Re: NEMA & ITI Comments on Energy Conservation Program: Minimum Energy Conservation Standards for Uninterruptible Power Supplies

Docket Number: EERE-2016-BT-STD-0022
Regulatory Information Number: 1904-AD69

NEMA & ITI (“Industry”) Comments on Energy Conservation Program: Minimum Energy Conservation Standards for Uninterruptible Power Supplies

Figure 1: DOE Tested VFD Efficiencies and the DOE Proposed Curve

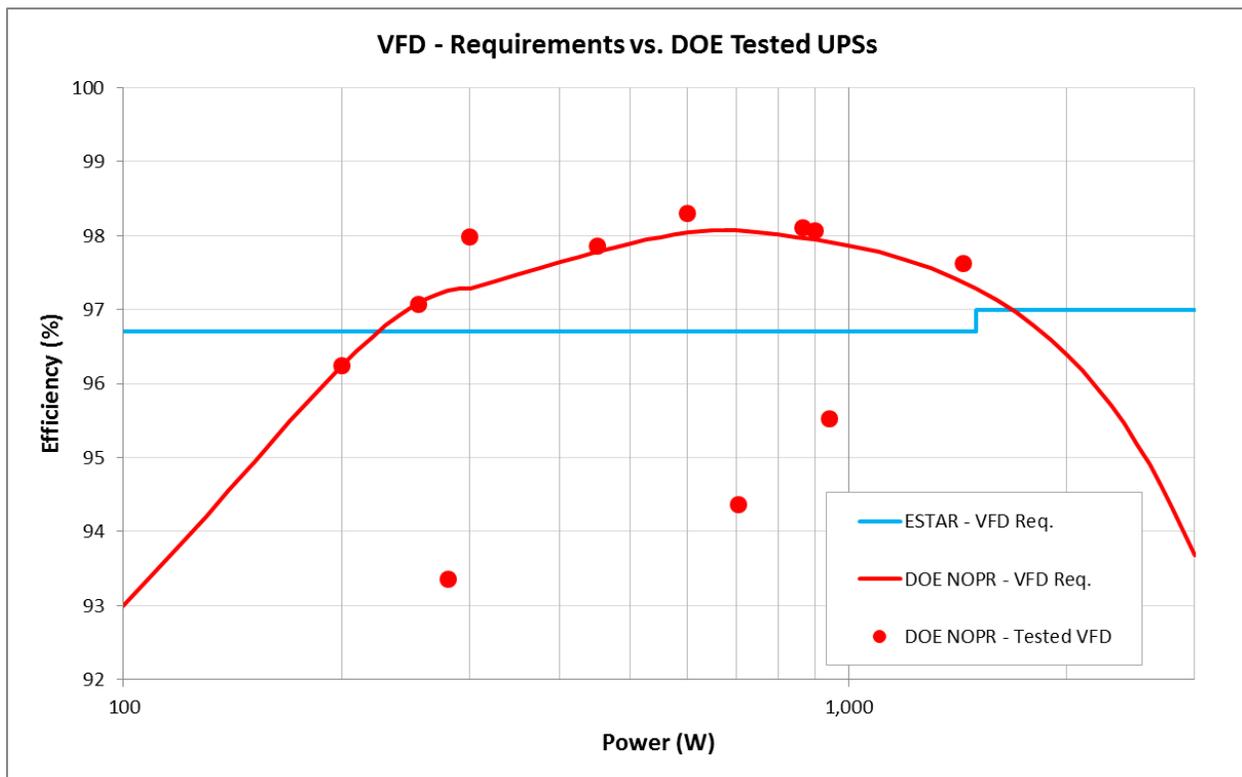
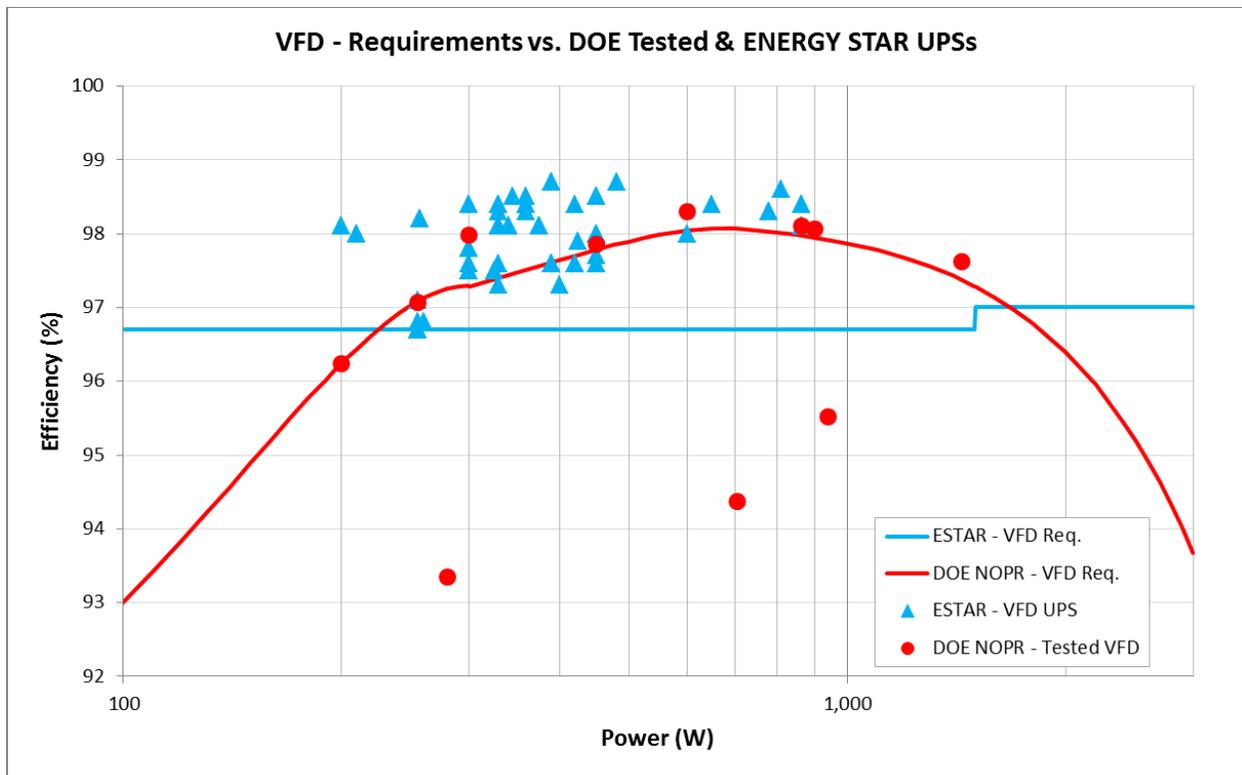
The proposed minimum efficiency curve for VFD products, as displayed in Figures 1 and 2 below, does not conform to any reasonable explanation for its shape, except that DOE sought to apply anything other than a straight line to the scattered plot of product efficiencies. The “cluster”, using this term loosely, of products tested above 96% efficiency as shown in Figure 1 would seem to be the visual encouragement which led DOE analysts to a curve-based proposal. However, this mistaken trend is illusory: if the greater data set of ENERGY STAR UPS efficiencies is added to the display, as shown in Figure 2, whatever basis the DOE had for selecting a curve disappears.

Figure 3: Industry Counterproposal for VFD UPS Efficiencies

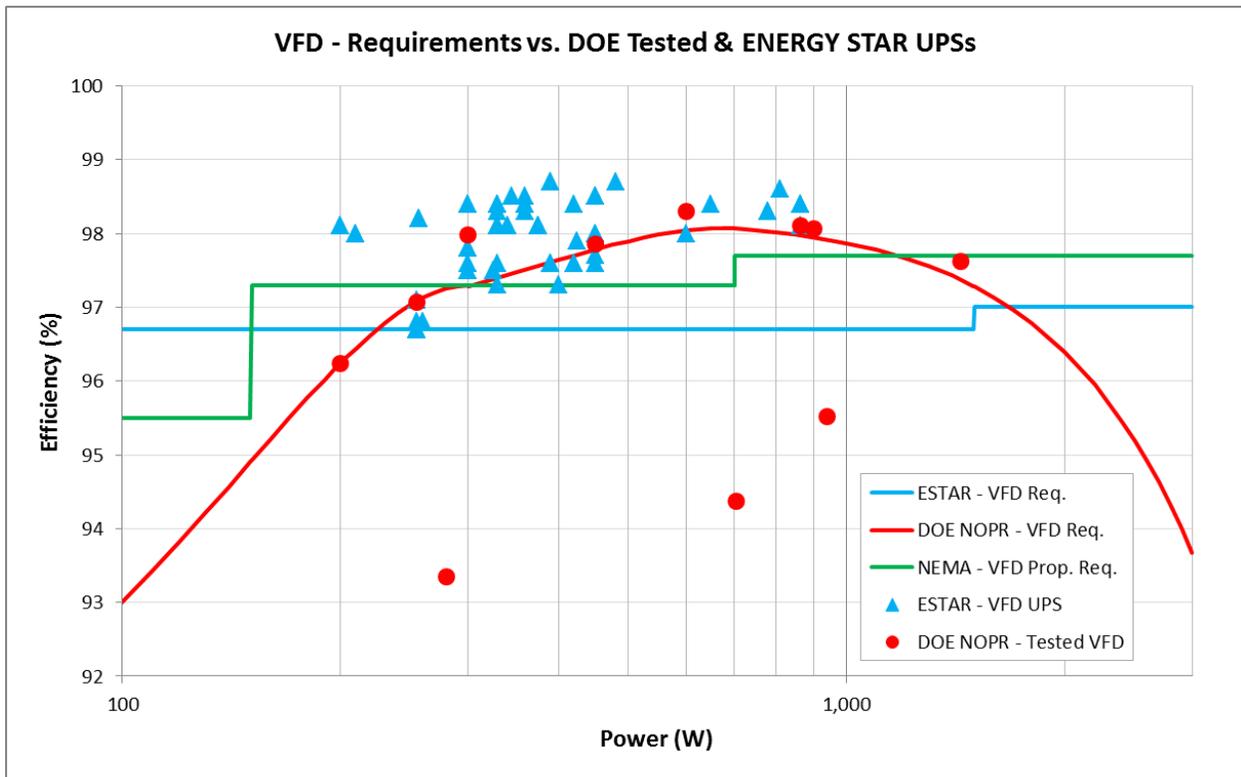
We propose the following efficiency levels for VFD products to replace the DOE’s (see figure 3 below):

1. For VFD UPS <150W: establish a level of 95.56% efficiency. These products have the highest amount of fixed losses by wattage, and are already at peak efficiency.
2. For VFD UPS $\geq 150W$ - $\leq 700W$: raise the minimum efficiency from 96.6% to 97.3%.
3. For VFD UPS >700W: raise the minimum efficiency from 96.6% to 97.7%.

Figure 4: ENERGY STAR and DOE Tested VI UPS Efficiencies vs. the DOE Proposed Curve

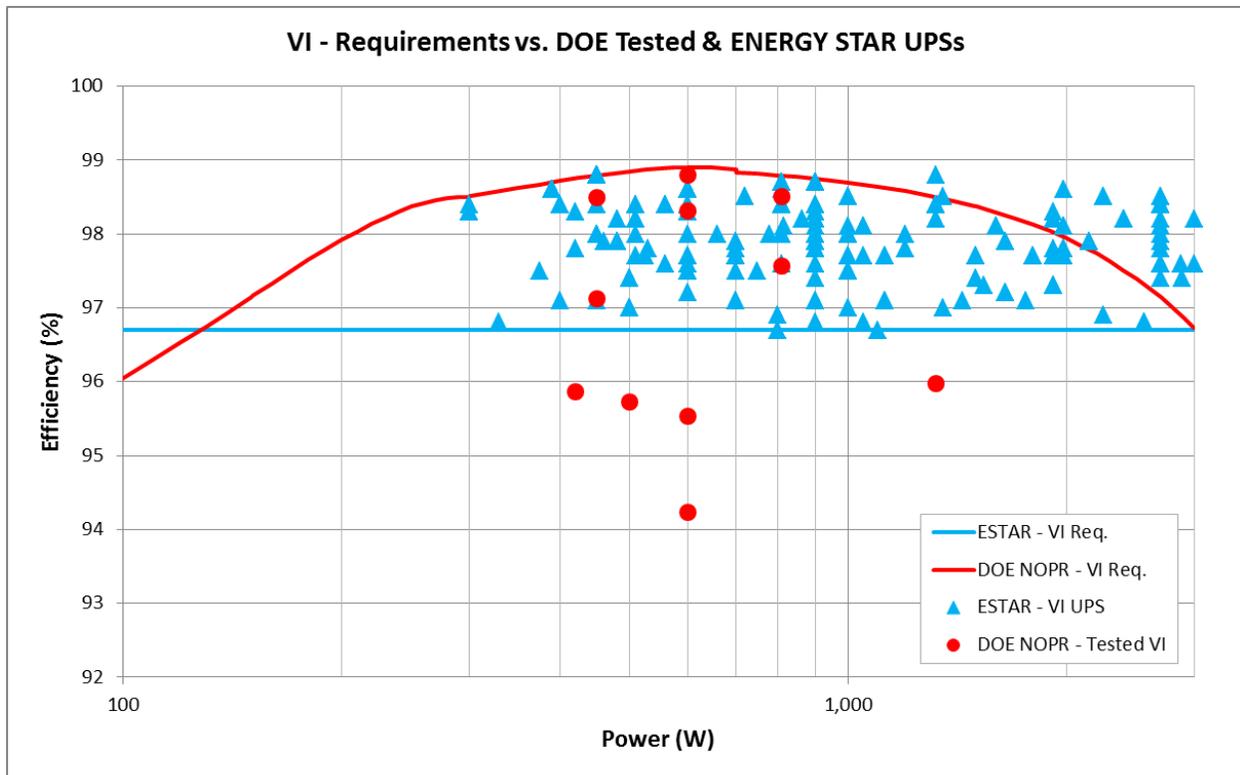
Having incorrectly concluded that a curve-based approach is the best way to regulate VFD products, the DOE carried this flawed reasoning over to VI and VFI products. By far, the worst feature of the Efficiency Levels proposed in the NOPR is the impact on VI products in the 0-1000 watt range. The DOE’s proposal, when represented graphically in figure 4 below, will effectively eliminate all products in this capacity range. As we note above in item 1, the remaining efficiency gain potential from technology options is insufficient assurance that efficiency gains can overcome the too-aggressive energy efficiency proposal coupled with the “loss” in efficiency due to test procedure changes. We note that, oddly, the DOE evidences the impact of its own strict proposal in the physical testing results for the VI class, where in figure 4 none of the DOE-tested units would pass the proposed EL.

Figure 5: Industry Counterproposal for VI UPS Efficiency

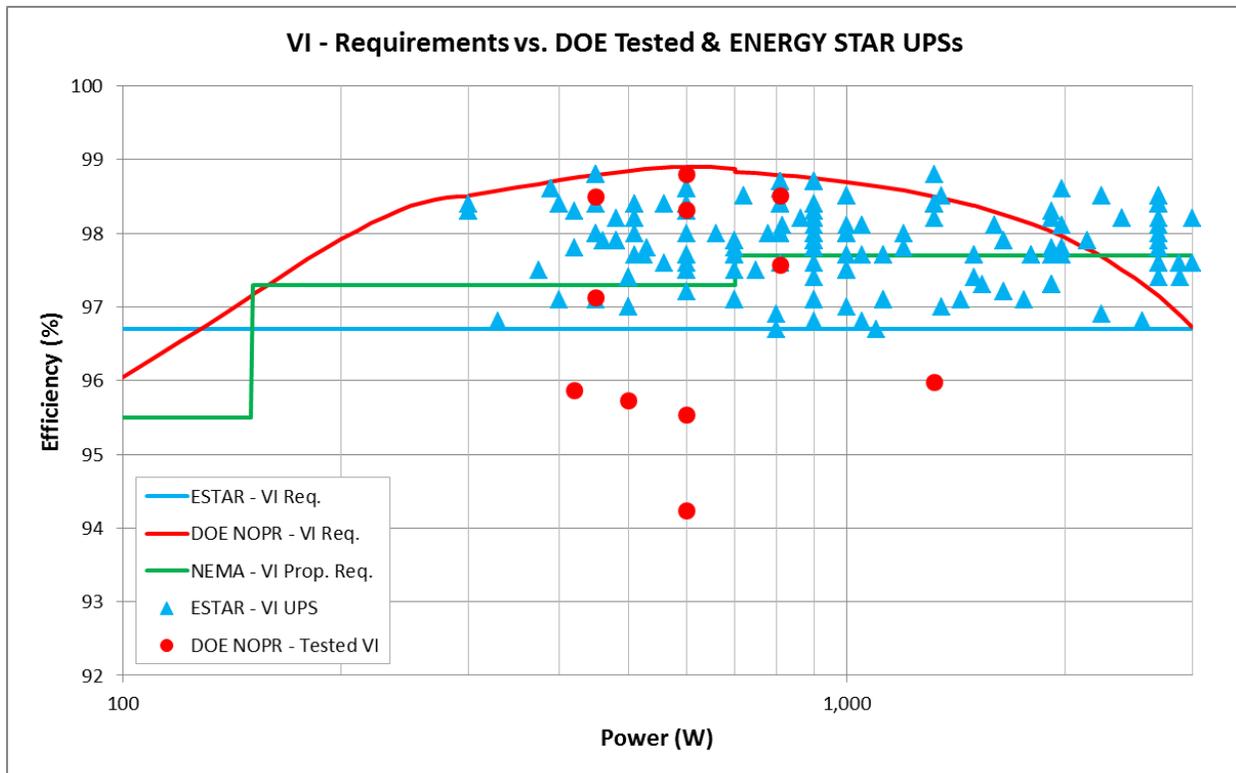
Because the efficiencies of VFD and VI products are similar, particularly after culling lesser-performing units, We propose DOE set the same requirements for VI that we have proposed for VFD. This will improve compliance because it will reduce confusion. By our estimates, this will eliminate roughly 39% of current products from the market. See figure 5.

Figure 6: ENERGY STAR and DOE Tested VFI UPS Efficiencies vs. DOE Proposed Curve

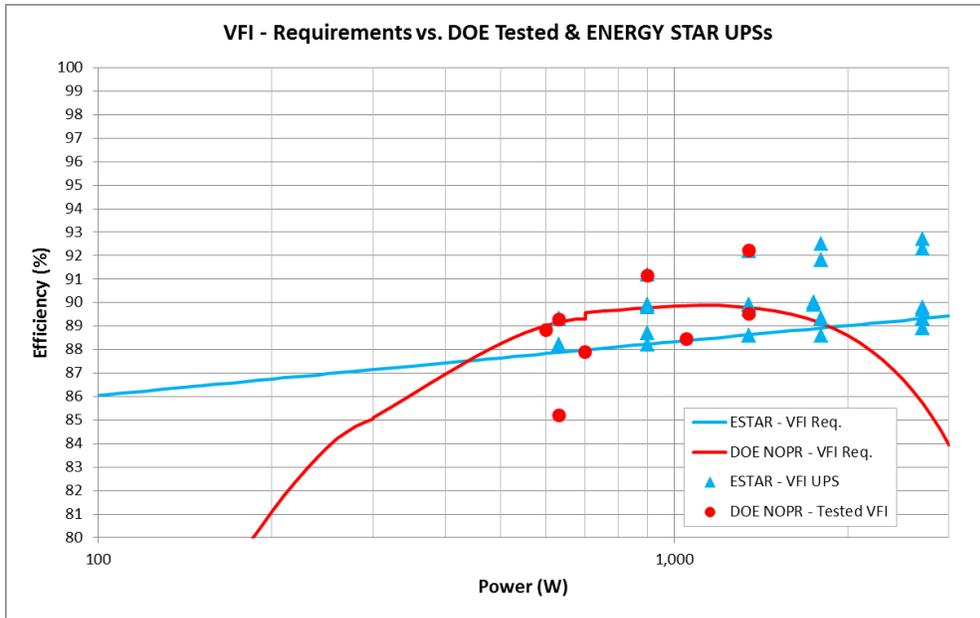
As before, the DOE proposal for VFI products unfairly prejudices lower-wattage units and does not offer sufficient leeway to maintain these consumer demanded capacities. There is no evidence in the DOE TSD or in the ENERGY STAR database that any products in the market will pass the proposed efficiency requirements for 700W capacity and below. The DOE is prohibited from eliminating this consumer demanded capacity range (footnote 1). Furthermore, there is no visual or mathematical reason why a curve-based approach fits this product class, given the available efficiency data. Again, the curve approach is apparently carried over from VFD products, despite its poor fit. See figure 6 for a graphic representation.

Figure 7: Industry Counterproposal for VFI UPS Efficiency

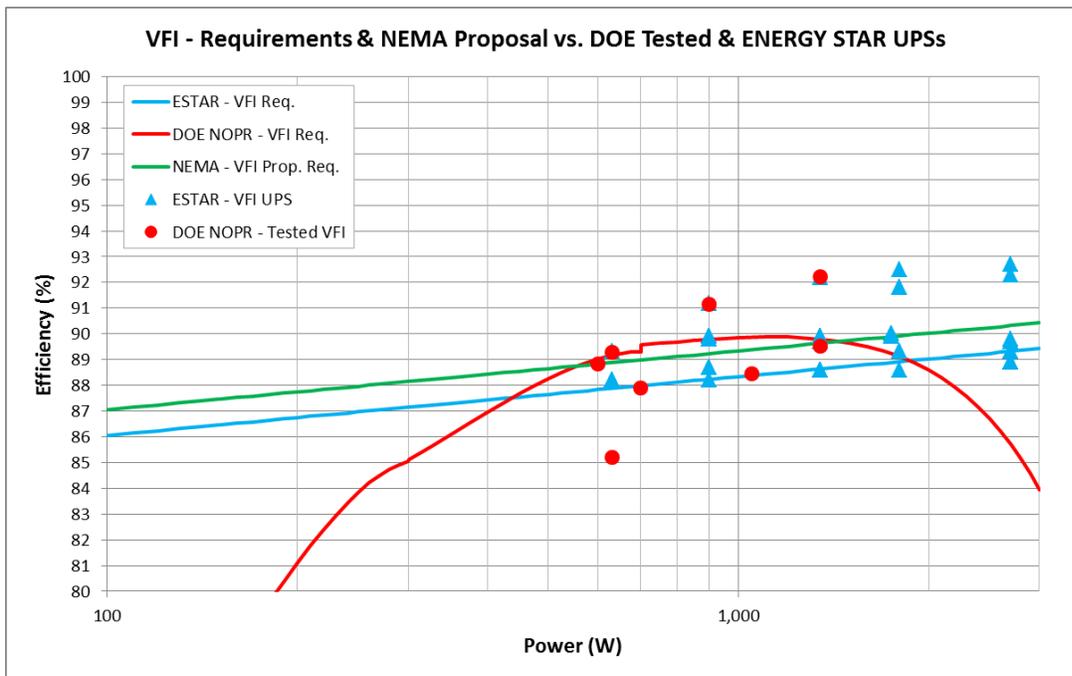
Rather than eliminate all the lower capacities of VFI products, the DOE should preserve the option of lower wattages by using a straight line approach to establishing minimum energy conservation standards for VFI products. The DOE proposal for VFI products would eliminate roughly 45% of products on the market today. We propose a sloped line that raises the ENERGY STAR efficiency level by 1%. This will likely eliminate approximately 65% of products on the market today; a significant improvement over the DOE's proposal. See figure 7.
